From: [Rodenbeck, Jay B.](#)
To: ["Amanda Bishop"](#)
Cc: [Blazar, Shahab](#); [Webb, Robert L.](#); [Wolfley, Jolene](#); ["Nancy Carreras"](#); ["Joey Winter@jll.com"](#); ["MKucaba@interplanllc.com"](#); ["Chrissy Schwartz"](#)
Subject: RE: URGENT 2021.1239 CFA#4107 Coors Boulevard - Approved Plans - Construction issues - Please help
Date: Monday, March 13, 2023 3:31:00 PM
Attachments: [image004.png](#)
[image005.png](#)

I am hoping you can help me as this is an urgent matter. We are currently working with PNM Electric on the transformer relocation for the existing Chick-fil-A located at 4001 Coors Boulevard NW. It has been brought to our attention that they current approved design by them will not work due to physical restraints regarding the Pull Box to the east of the site. Also along the right-of-way is a joint trench which is causing problems as well. With that being said we started to look into redesign. We are looking at having to do a new easement for the running of a new powerline.

TIER 3 OUTSIDE MEAL DELIVERY CANOPY

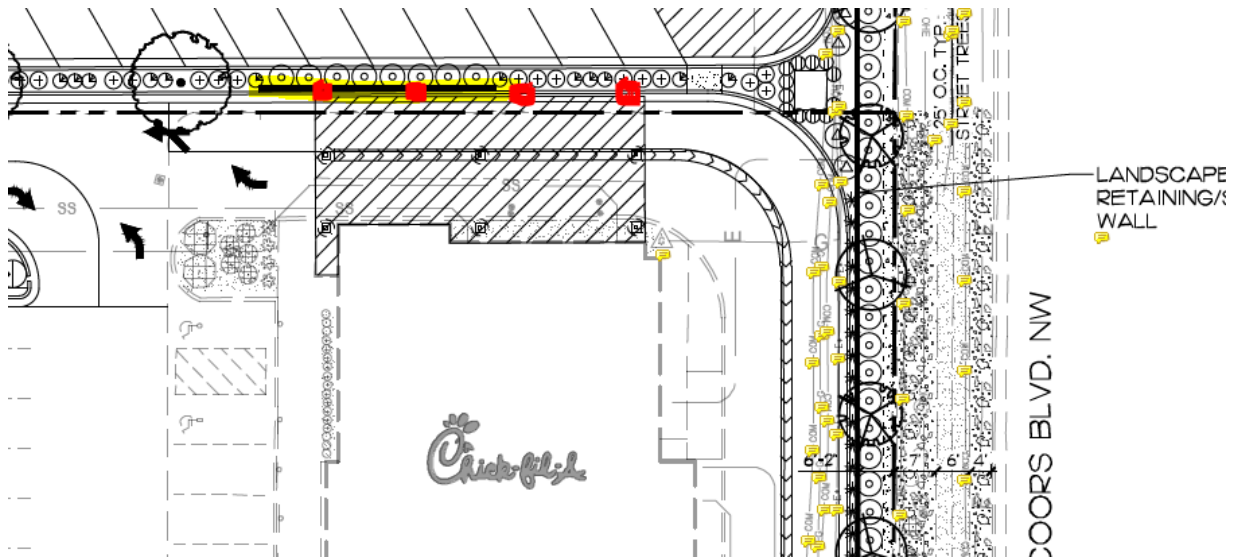
Upon looking at the redesign of where to run the power line, it was noticed that the DRB stamped approved site plan shows there are canopy columns through the middle of the drive-thru (see highlighted snippet below.) Chick-fil-A does not place columns in the middle of the order meal delivery canopy in case cars need to exit the drive-thru or "bypass" cars if guests have received their meal(s). With that being said, the canopy columns should be placed on the outside of the canopy in the landscaped island to the north (please see the red dots in the snippet below).

In addition to the issue above, there ALSO is suppose to be 4 canopy columns and footings not 3.

Now, cross referencing the above plan to our building plans which were stamped approved by the Albuquerque Building Department (this Please see the highlighted snippet below), the columns are in fact in their correct location. I believe as though when submitting this, it should have been caught by my team as well as the reviewers at the city as all documents had to be submitted for review.. I am looking to discuss what options we have and I am needing to get that rectified ASAP! PLEASE HELP! The red x's below show where they are per the site plan, but those are incorrect. I am going to need to get that fixed on our civil plans.

- With all this being said, it has also brought two other issues;
1. The canopy columns being placed in the landscape island “technically” will not work with the retaining wall that I believe was “required” from the City/grading. (There is also a second one that runs along Coors Blvd which was also a requirement by the city.) Please see the snippet below where the highlighted yellow is the screen wall and where the red dots are suppose to be the canopy columns.
 2. **What does this mean for approvals? What does this mean for review? How can I rectify this situation. PLEASE HELP!**

If the DRB approved the Site Plan Amendment with the layout as depicted on the approved Building Plans and the DRB-signed copy of the Site Plan Amendment had Plan sheets mistakenly included in the DRB-signed copy of the Site Plan Amendment, we can re-distribute the Site Plan Amendment for DRB signatures to match up with the approved Building Plans.

However, if the layout on the DRB-approved and signed Site Plan Amendment differs from the approved Building Plans, then an Administrative Amendment to the DRB-approved Site Plan Amendment must be applied for and approved. As it sounds, an Administrative Amendment is reviewed by staff and doesn't go through a hearing like your Site Plan Amendment did. Provided that no additional land disturbance is created and no changes to access or circulation are created, a revised Grading and Drainage Plan and TCL shouldn't be required, significantly reducing the review time of an Administrative Amendment.
